CONSULTATION REPORT

1-5 Reynolds Street, Hampton East

March 2022

Prepared for: **Reynolds Street Developments Pty Ltd &
Housing Choices Australia**

Figure 3 – Eastern Laneway changes

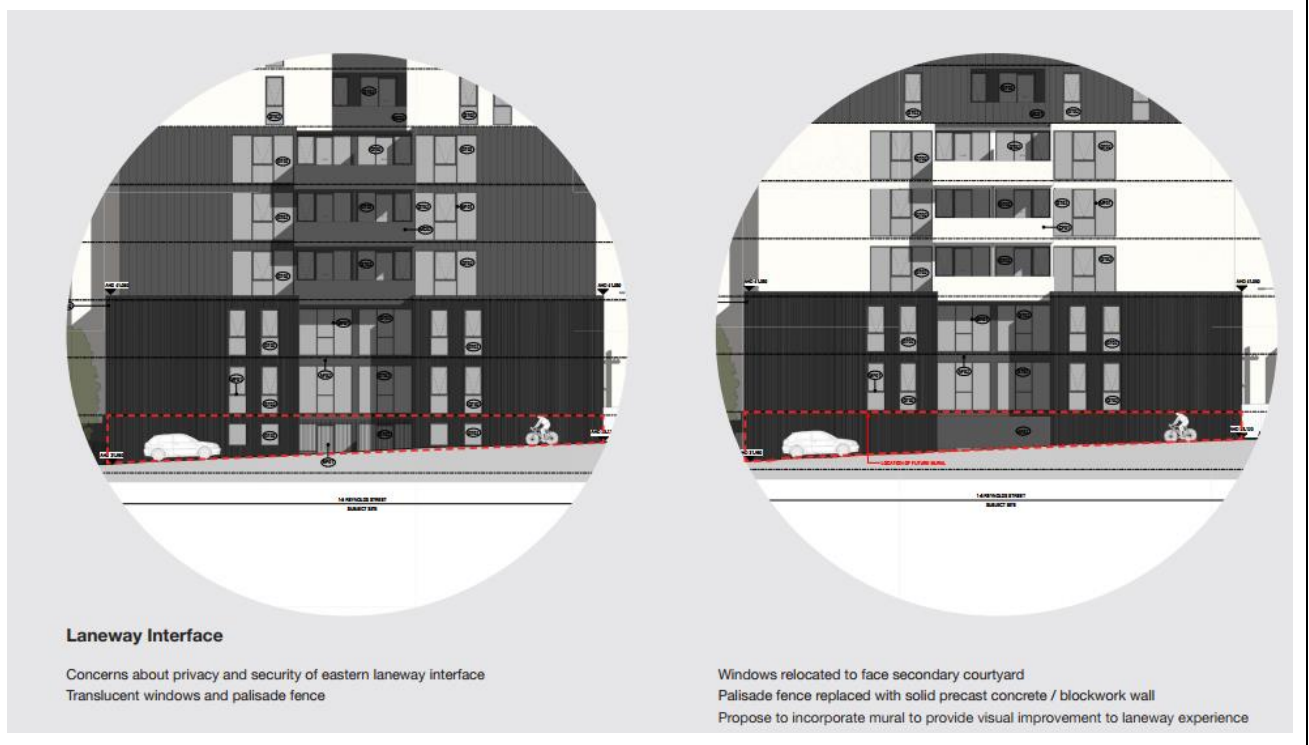
<p><i>eastern laneway requires review. We are concerned about the lack of safety and activity here. The bedroom windows facing the laneway are very vulnerable and a strategy regarding privacy and security is needed without compromising internal amenity.</i></p>	<p>facing the eastern laneway have been removed in response to OVGA feedback and repositioned to the eastern, central void for internal amenity purposes.</p> <p>Ground floor windows have been replaced by a feature mural wall for activation and interest at street level as this connects through to the retail core along Nepean Highway as reflected in Figure 3 below.</p> <p>Beyond initial changes made in Figure 3, upper level balconies and windows will be repositioned to further respond to OVGA comments, along with exploring an expanded mural for the streetwall, providing added activity, safety and passive surveillance.</p>	<p>ground floor windows to eastern laneway</p> <ul style="list-style-type: none"> • Provision of a feature mural wall to the eastern laneway for added activation and interest. • Balconies on upper level orientated with dual-aspect, including towards eastern laneway

Figure 6 – Increased central lightwell and core rotation

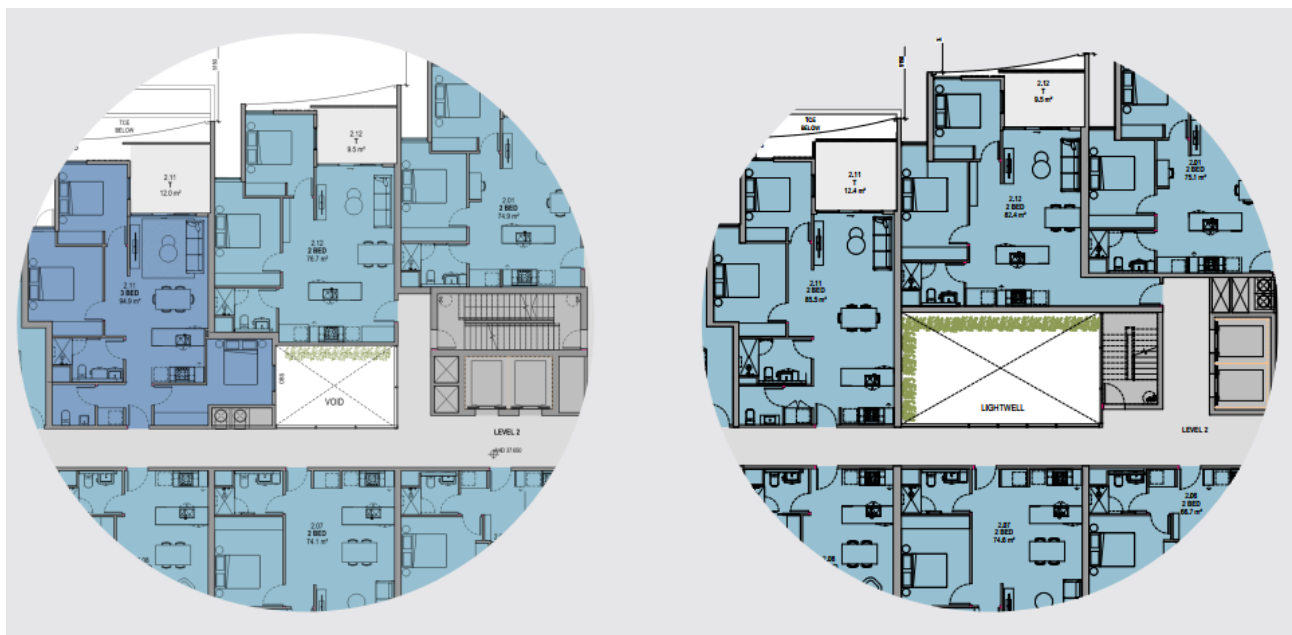
13. <i>The planting at the bottom of the lightwell will be difficult to sustain given the lack of light penetration.</i>	The central lightwell has significantly increased in response to OVGA feedback, providing excellent daylight penetration, notably in excess of BESS requirements This lightwell is to be further expanded through the relocation of	<ul style="list-style-type: none"> • Lightwell to be further expanded beyond consultation material as part of the submitted application • Further detail of landscape strategy and planting within lightwell to be provided by <i>Etched at</i>

<p>the waste chutes and core orientation and which will form part of the submitted application as reflected in Figure 6 below.</p> <p>Given the basement layout, the planting within the lightwell is to be contained within planters.</p>	<p>application submission</p>
--	--	---	-------------------------------

Figure 7 – Provision of internal communal facility/area

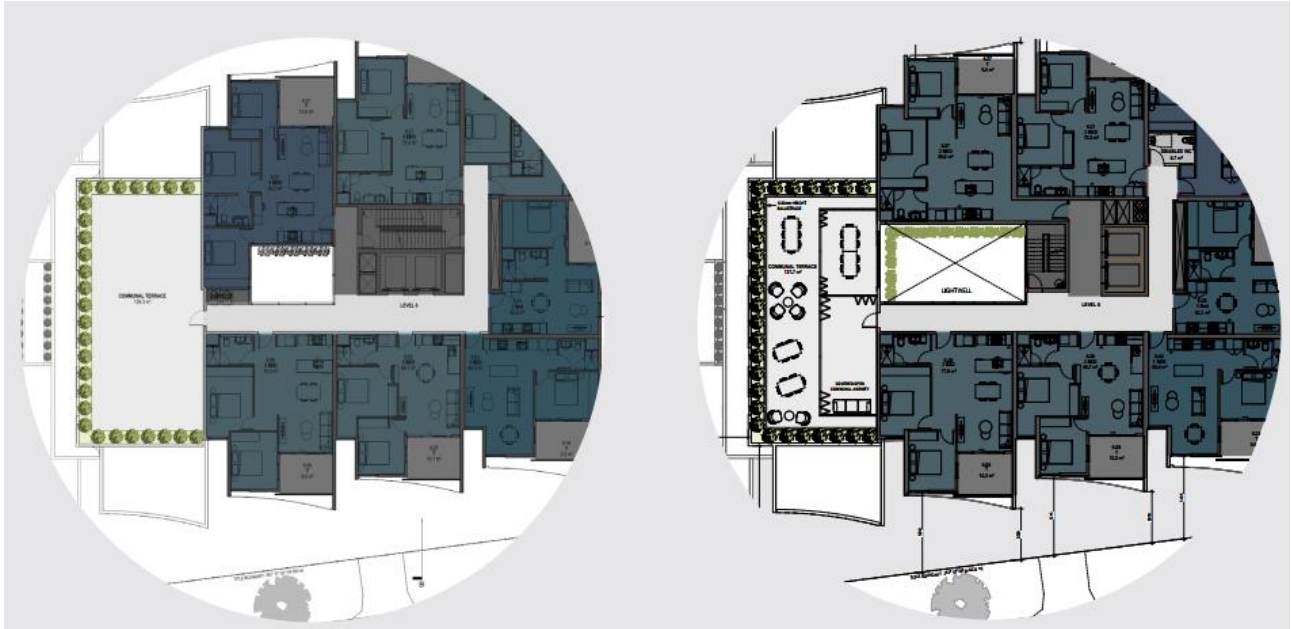
<p>14. <i>The existing planning permit scheme shows communal roof spaces. While the roof terrace remains, internal communal facilities have been lost in the updated eight storey scheme. We are concerned about the roof terrace now being located adjacent to private residences. For a vulnerable population of this scale internal communal spaces need to be included to facilitate interactions between residents and to provide spaces outside of dwellings. Locating internal communal facilities adjacent to the external communal space is logical and recommended. The communal roof terrace needs to be usable</i></p>	<p>An internal communal facility/area has been provided at Level 6 in response to OVGA comments and as reflected in Figure 7 below.</p> <p>This provides separation from apartments to the external area and a desirable amenity for residents of the building with opportunities for this to be open/closed depending on weather conditions.</p>	<p>No further changes necessary</p>

throughout the year in different weather conditions and cater for the residents' daily activities.

Figure 9 – Recessed uppermost level

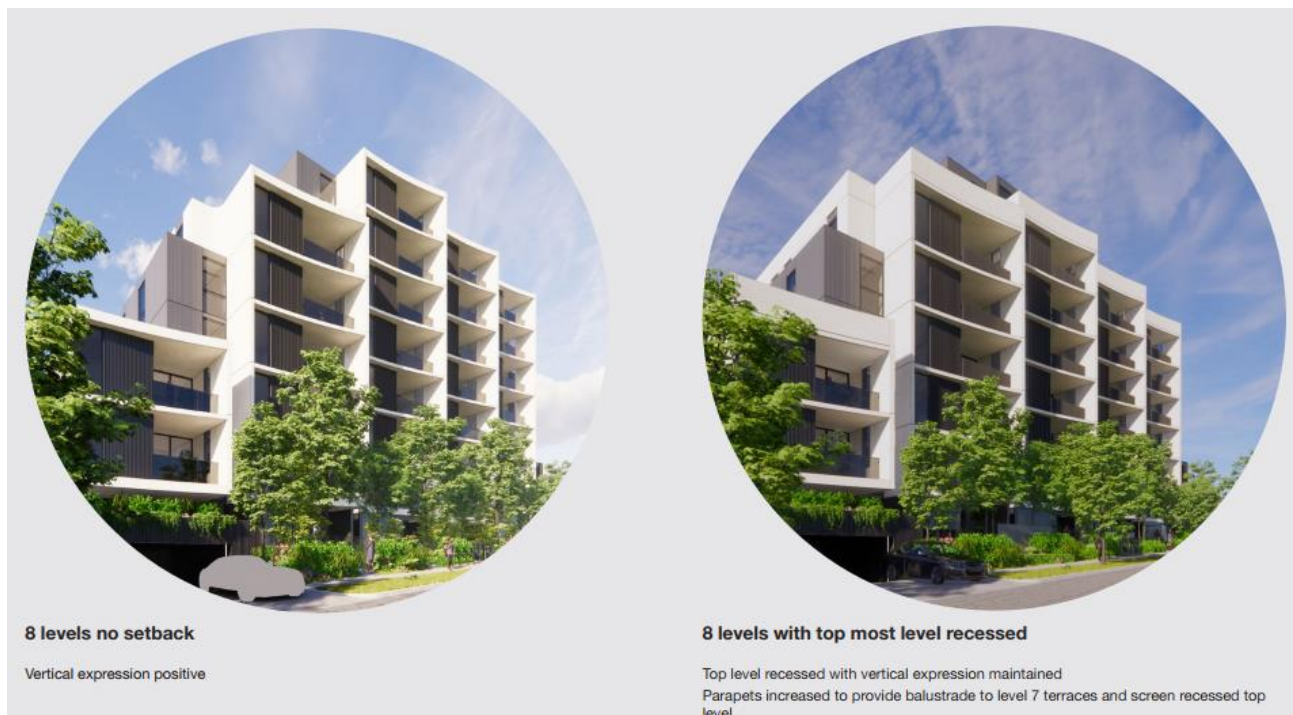
Table 2: Bayside City Council conditions response			
Condition Reference	Condition	Response	Proposed Change
1a)	<i>Deletion of Level 7. The new uppermost level (excluding rooftop level) must be further recessed from the front façade, and designed of a more muted design detail</i>	The architectural response was updated in response to earlier Council feedback at the pre-application meetings by removing bedrooms on Level 7, resulting in a recessed uppermost level as reflected in	No further changes beyond that provided in the consultation package which informed: <ul style="list-style-type: none"> • Recessive uppermost level to enable the

<p>the comparative perspective images at Figure 9 below.</p> <p>The height of the proposal at eight (8) storeys, is two (2) storeys higher than the discretionary built form control within the ACZ1. As a result of these additional storeys, this does not impact on the proposal's ability to comply with the objectives and requirements of the ACZ1 control. The redistributed Reynolds Street streetwall from the Planning Permit for additional height as proposed, provides for an improved public realm and pedestrian outcome through a softer, landscaped streetscape in response to specific design guidelines for Precinct 3 of the ACZ1 including '<i>beautification of the Reynolds Street streetscape</i>' and '<i>distinct canopy planting...to achieve a leafy residential landscape character</i>'. Such redistribution of built form satisfies relevant objectives and requirements of the ACZ1, all while maintaining a similar Gross Floor Area to the existing Planning Permit.</p> <p>As a result of the building's height, no additional unreasonable off-site amenity impacts will arise given the generous setbacks provided and negligible overshadowing cast to the western properties as well as the public realm.</p> <p>Through the scaling of setbacks to the west and the differing heights this creates to the vertical modules to Reynolds Street, this proportionally balances the built form in responding to the Site's natural east-west slope which would also be lost if the</p>	<p>building to present as a seven (7) building in response to earlier feedback</p> <ul style="list-style-type: none"> • Reduction in the footprint of the uppermost level

<p>height were reduced.</p> <p>Accordingly, based on the above and response to community submissions received at Section 4.3 which also raises issues in relation to building height, a reduction in height is not necessary in this instance.</p>	
--	--	--	--
